ADDENDUM NO. 2:

Date: February 6, 2026

Project: Verbena HS Gym
DCM# 2025629
WSM# 25-032

Owner: Chilton County Board of Education
Architect: Ward Scott Morris Architecture, Inc.

① LUMINAIRE P3, P4, & P5
POLE FOUNDATION DETAIL
NOT TO SCALE

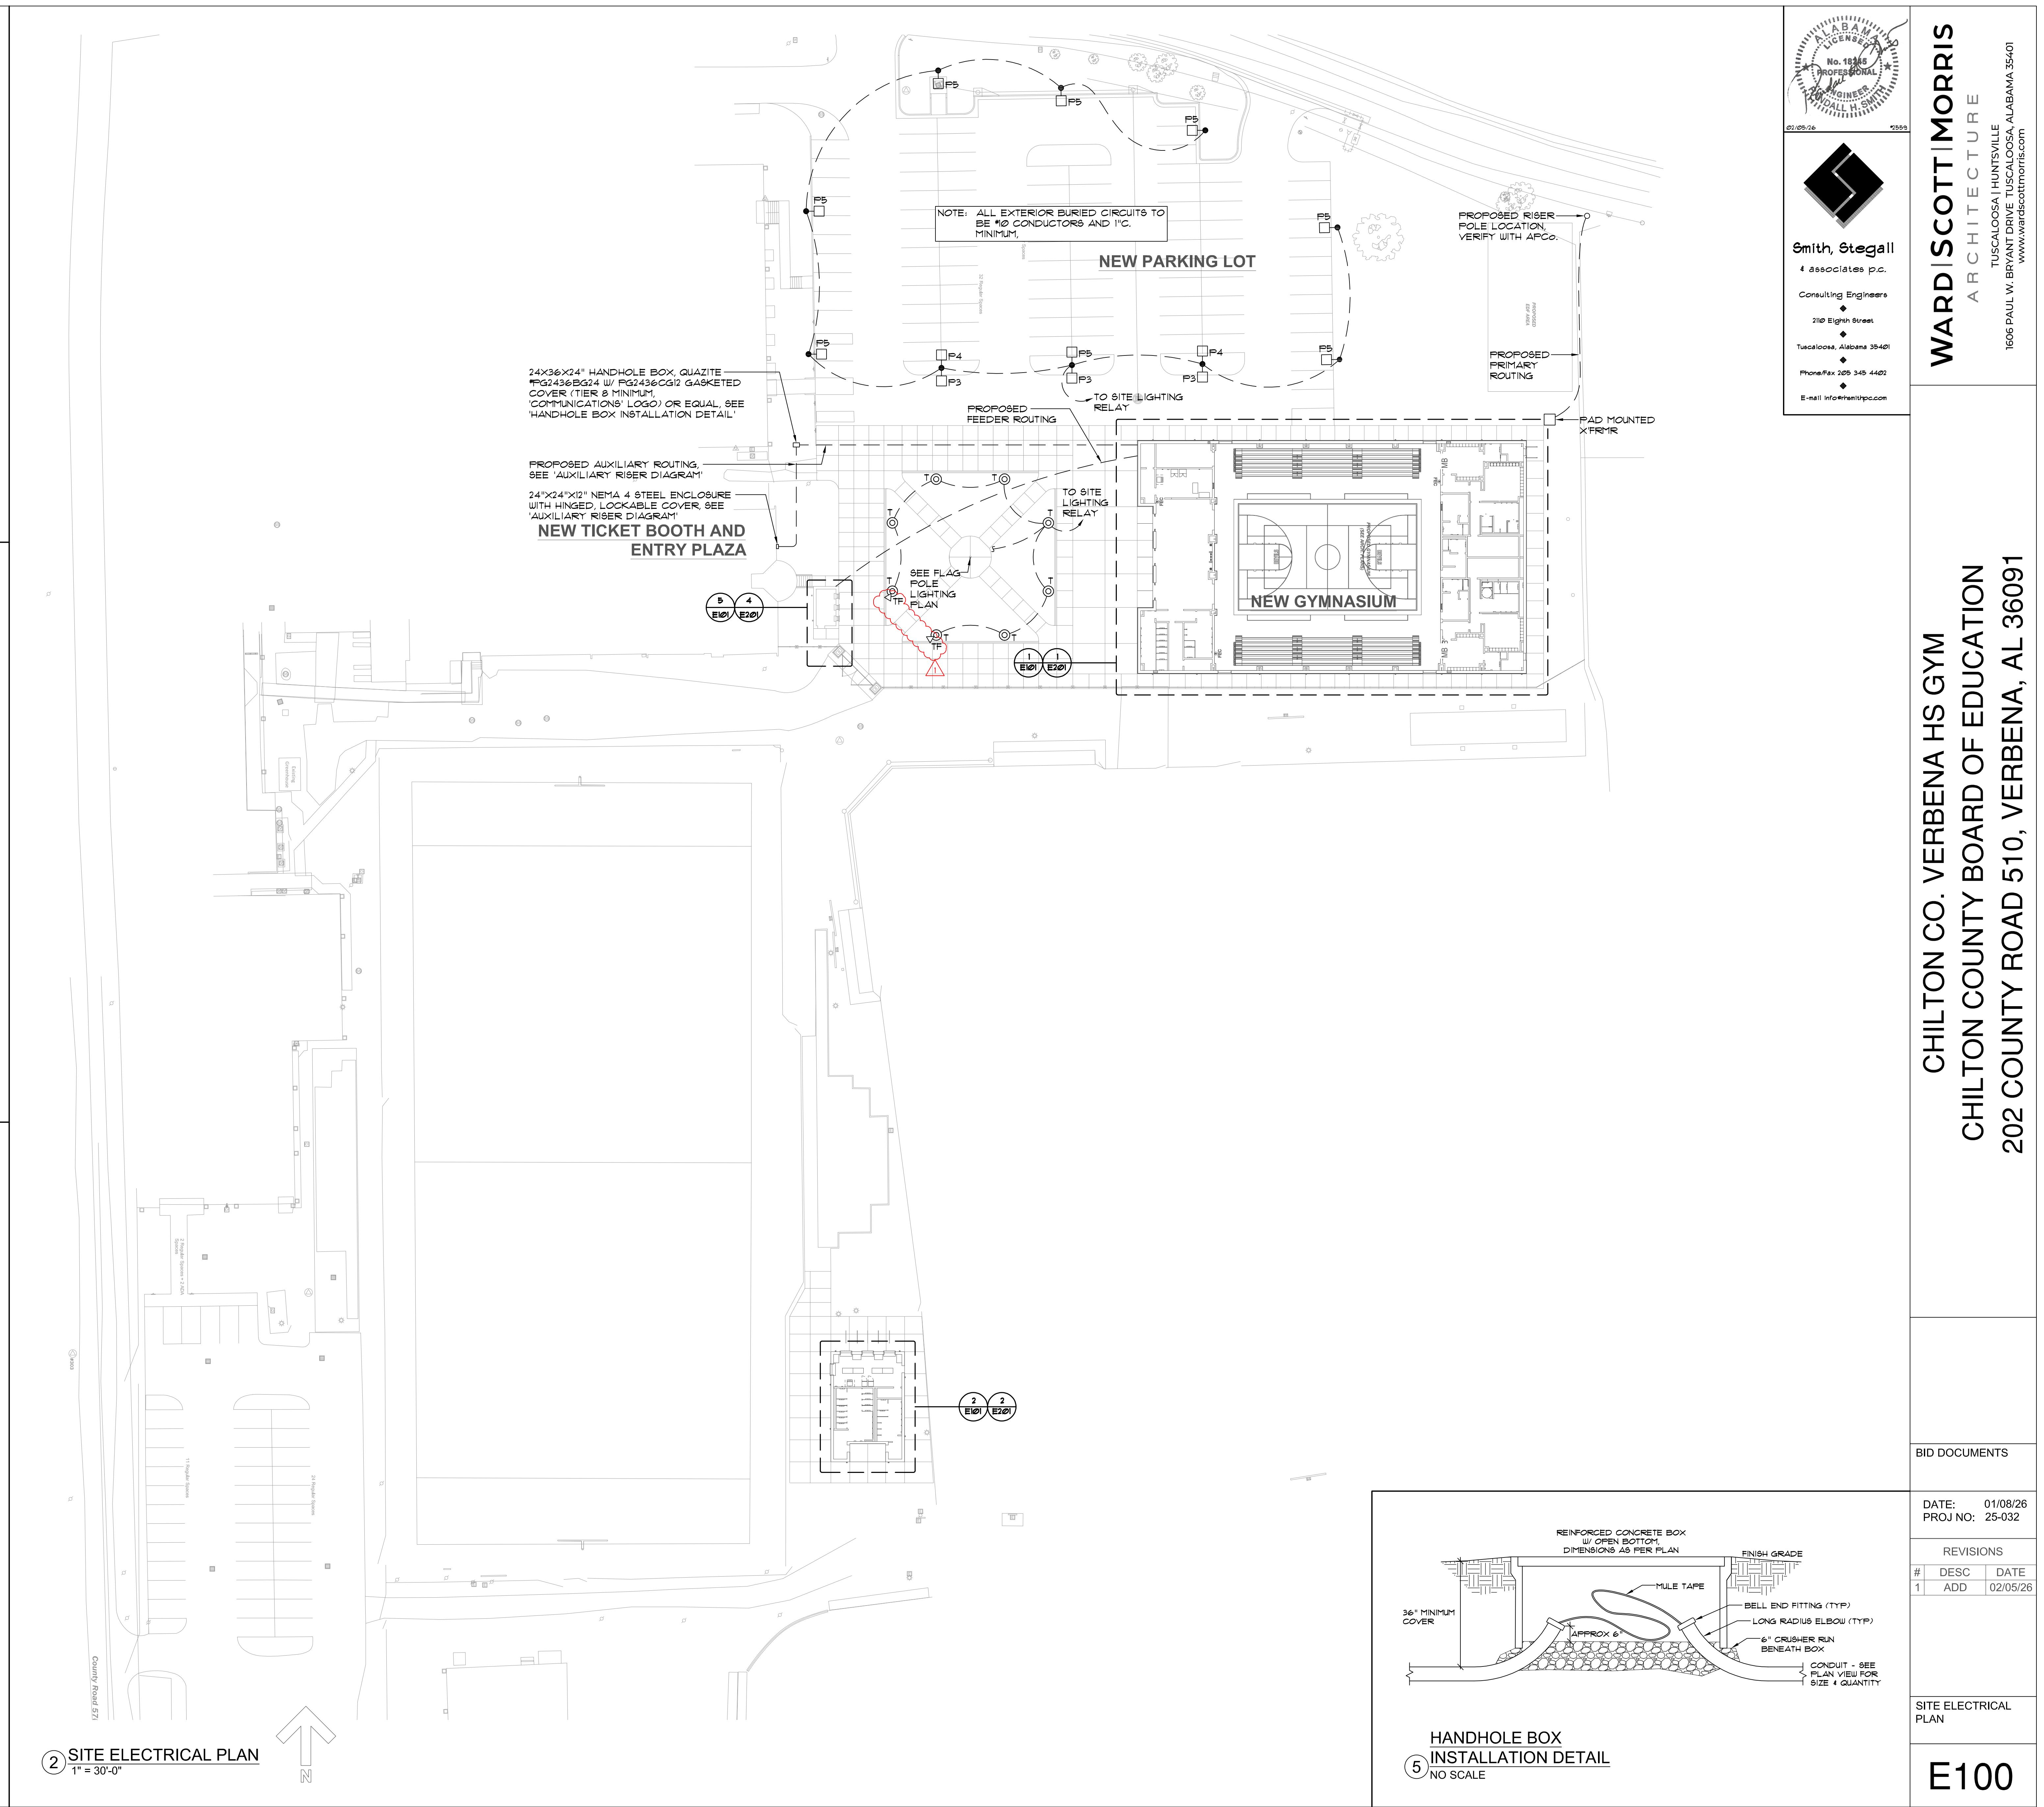
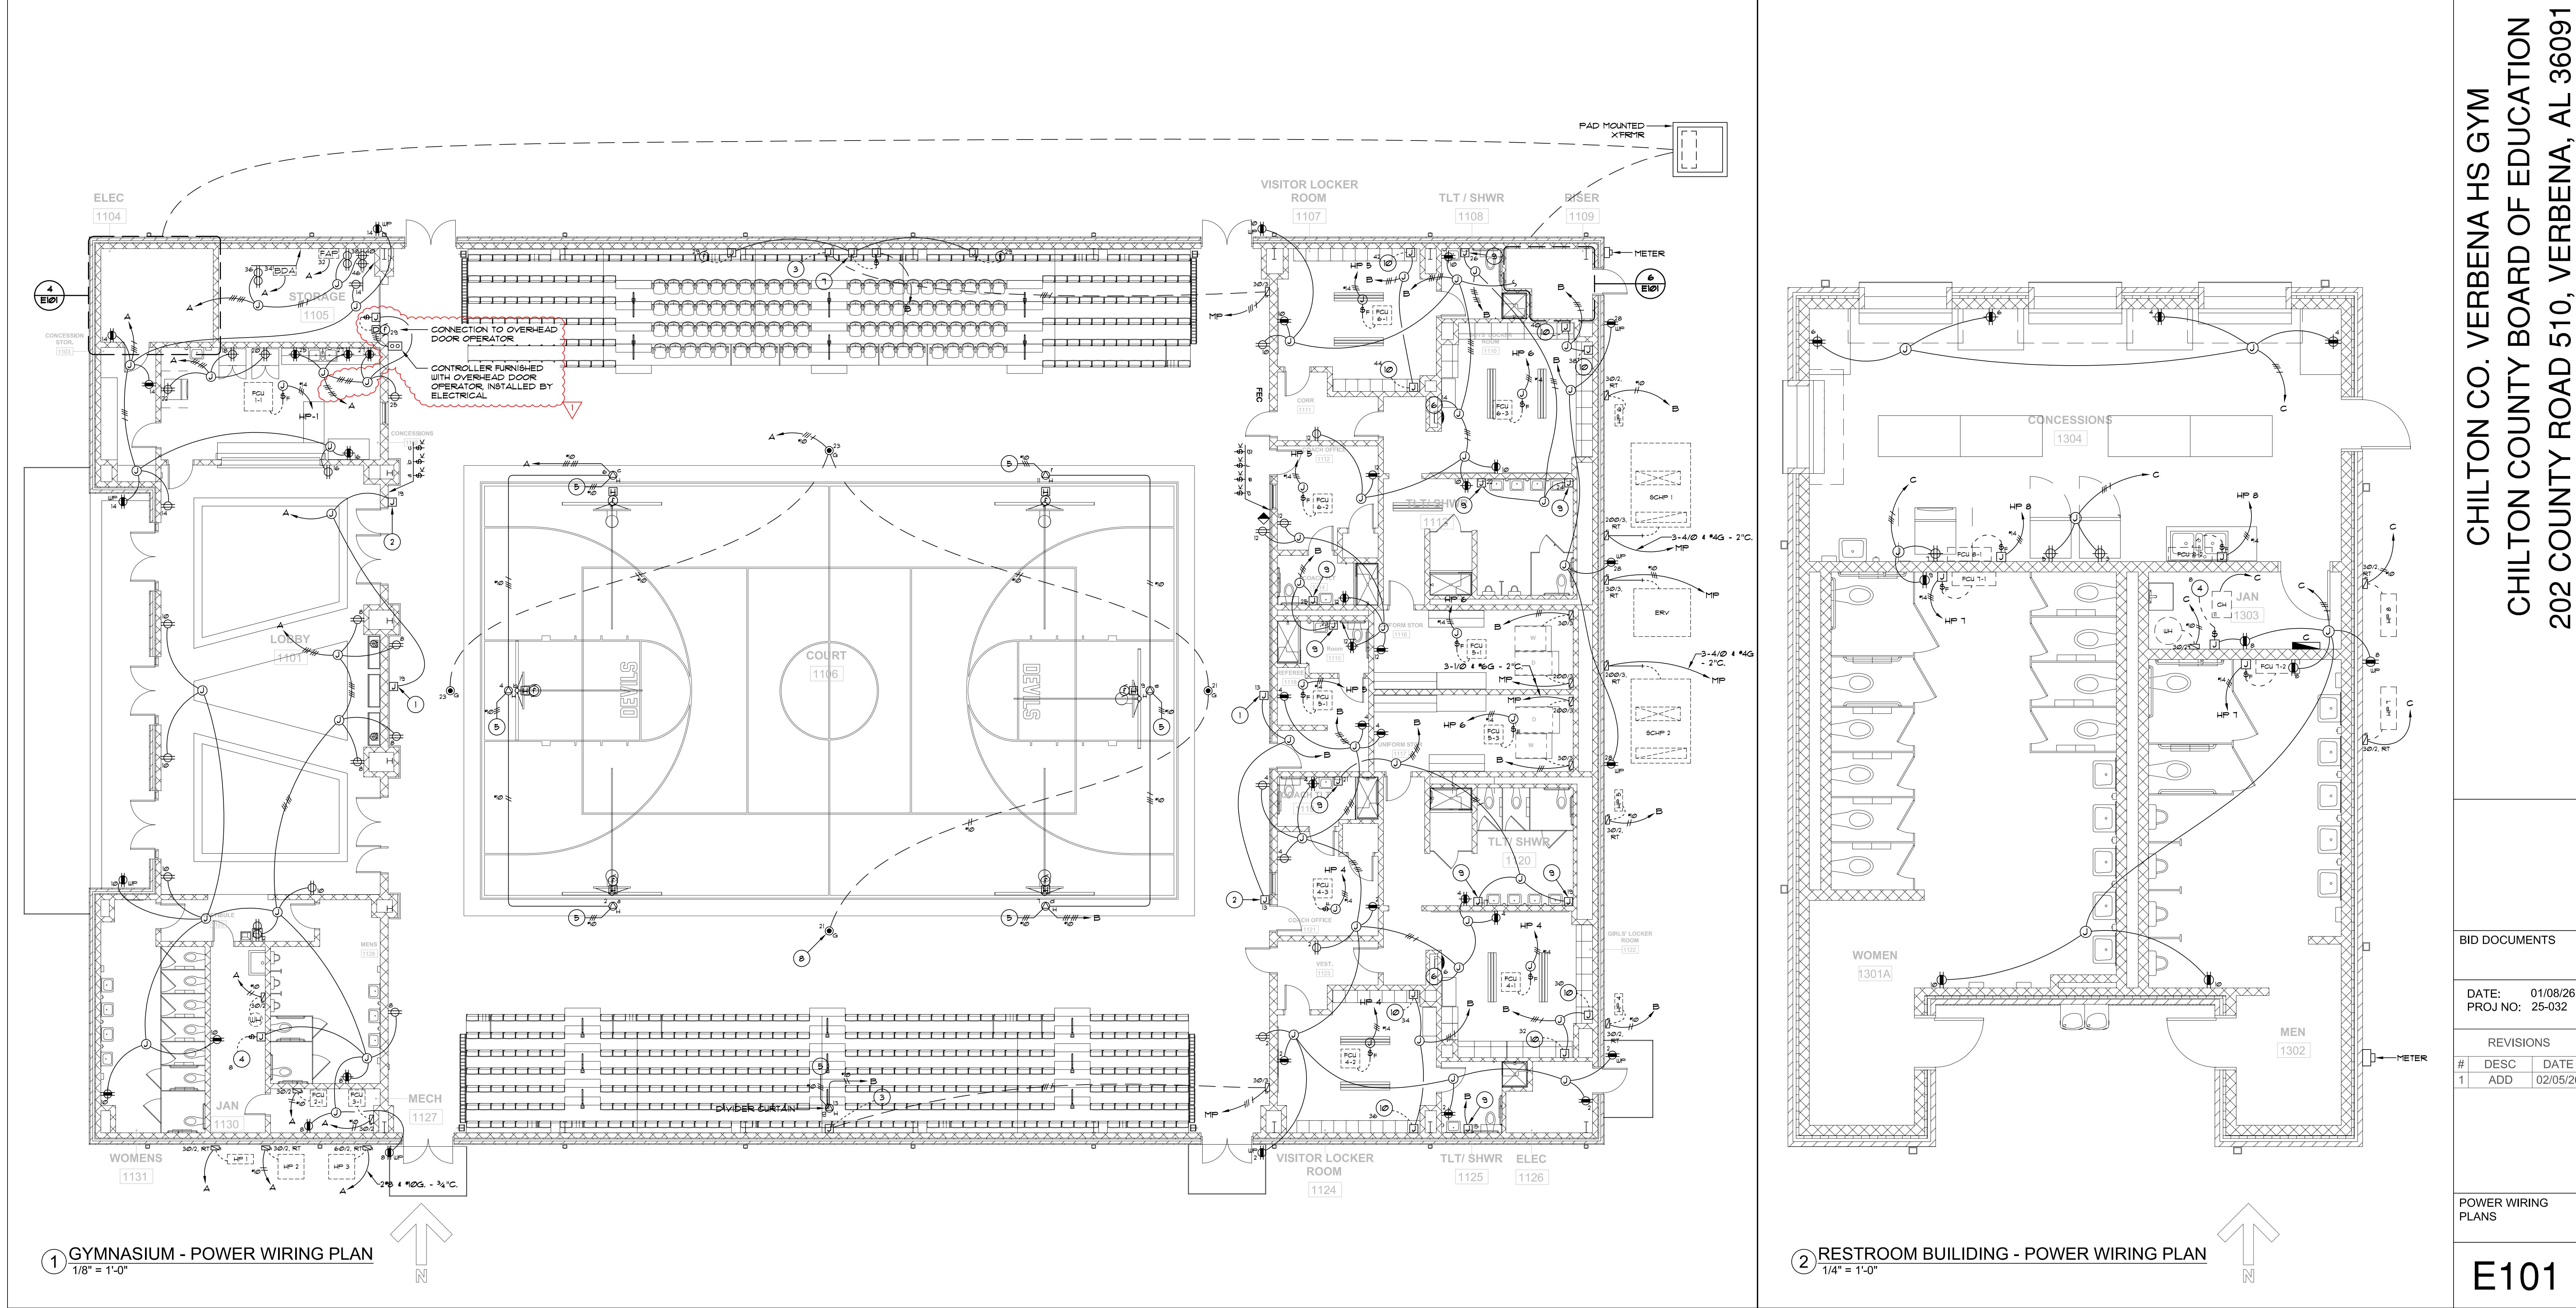
1. **Sheet E002:** See attached sheet for clouded revisions
2. **Sheet E100, Site Electrical Plan:** See attached sheet for clouded revisions
3. **Sheet E101, Gymnasium – Power Wiring Plan, Storage 1105:** See attached sheet. Power added to overhead door.
4. **Sheet E300:**
 - a. **General Auxiliary Notes:** See attached sheet. Notes regarding BDA system bid procedures modified to match specification sections 012200 (Unit Prices) and 012100 (Allowances)
 - b. **Auxiliary Riser Diagram:** See attached sheet. Fiber type revised from OM1 to OM3. Fiber from existing building now shown to be plenum rated.
